May 23, 2019

**Re: DEP HDD Re-Evaluation Report – Request for Additional Information
Joanna Road Crossing 16" Horizontal Directional Drill Location (S3-0250-16)
Permit No. E06-701
Caernarvon Township, Berks County**

BERKS COUNTY, PENNSYLVANIA - CAERNARVON TOWNSHIP
S3-0250-16

HORIZONTAL DIRECTIONAL DRILL
JOANNA ROAD
PENNSYLVANIA PIPELINE PROJECT

Illustration of Bedrock Level at Subsidence Location and Compared to Redesigned 16-Inch HDD

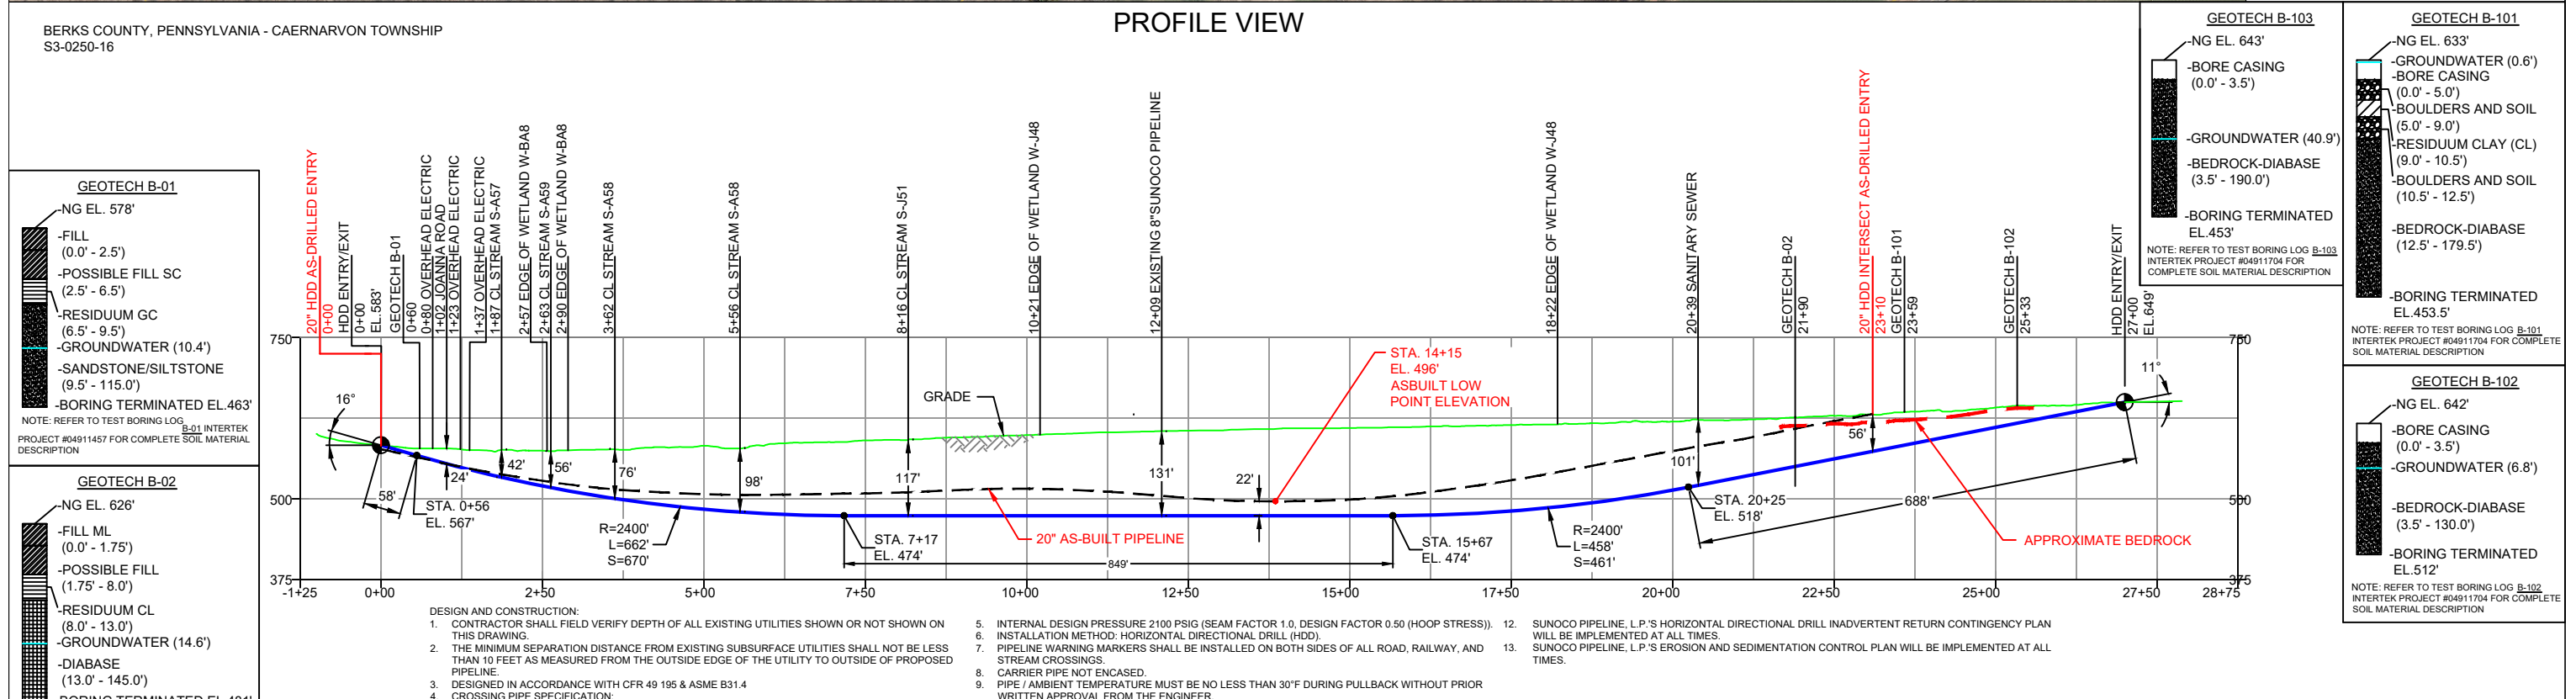
- 1. As required by Paragraph 4 and 5 of the Environmental Hearing Board's August 10, 2017 Corrected Stipulated Order, SPLP failed to fully utilize information gathered during the HDD of the 20-inch bore as part of the HDD Re-evaluation for the 16-inch pipeline. Please utilize the geologic and drilling logs of the 20-inch pipeline bore in conjunction with the boring data on the alignment to demonstrate and support how the proposed drill pathway will assuredly travel in the bedrock for a significant distance beyond the previous eastern exit hole. Plot this information on the proposed drill path profile.**

This information should then be used to describe why the chosen bore path for the 16-inch pipeline was determined and how such information has been used to minimize the potential for IR's to occur and as part of the discussion of construction alternatives, including why HDD activity is still the preferred and chosen methodology for pipeline construction at this location.

The attached figure presents the top of bedrock profile overlain onto the proposed 16-inch HDD plan and profile. As shown on this figure, the asdrilled profile for the 20-inch pipeline is above bedrock where the subsidence occurred. The redesigned 16-inch pipeline will be entirely within the bedrock until passing through the unconsolidated overburden immediately prior to the HDD entry/exit points.

To reduce the potential for IRs during completion of the proposed 16-inch HDD, the profile was redesigned and the entry and exit angles and overall length of the 16-inch HDD profile were increased. By increasing the entry and exit angles, the redesigned 16-inch HDD will be advanced through the unconsolidated soils and weathered bedrock more quickly and closer to the respective entry and exit points. By lengthening the 16-inch profile, the revised bore path will be completed in more competent bedrock nearer the land surface. The modifications to the 16-inch profile will also allow the HDD boring to avoid the area of large diabase boulder/soil matrix encountered during completion of the 20-inch HDD. Further, the overall depth of the profile has been increased from a maximum depth of 100 feet below ground surface (bgs) on the permitted 16-inch profile, to 140 feet bgs on the redesigned 16-inch profile to have more of the boring advanced through the bedrock containing higher rock quality designation (RQD) values. The RQD values for the 20-inch profile were generally considered good; however, to further reduce the potential of IRs during the installation of the 16-inch HDD, the profile was redesigned to intersect more competent bedrock and to avoid intervals of bedrock which contained multiple fractures as identified in the 2017 geotechnical investigation. These design changes, along with best management drilling practices, will be used to reduce the risk of IRs from occurring during completion of the 16-inch HDD.
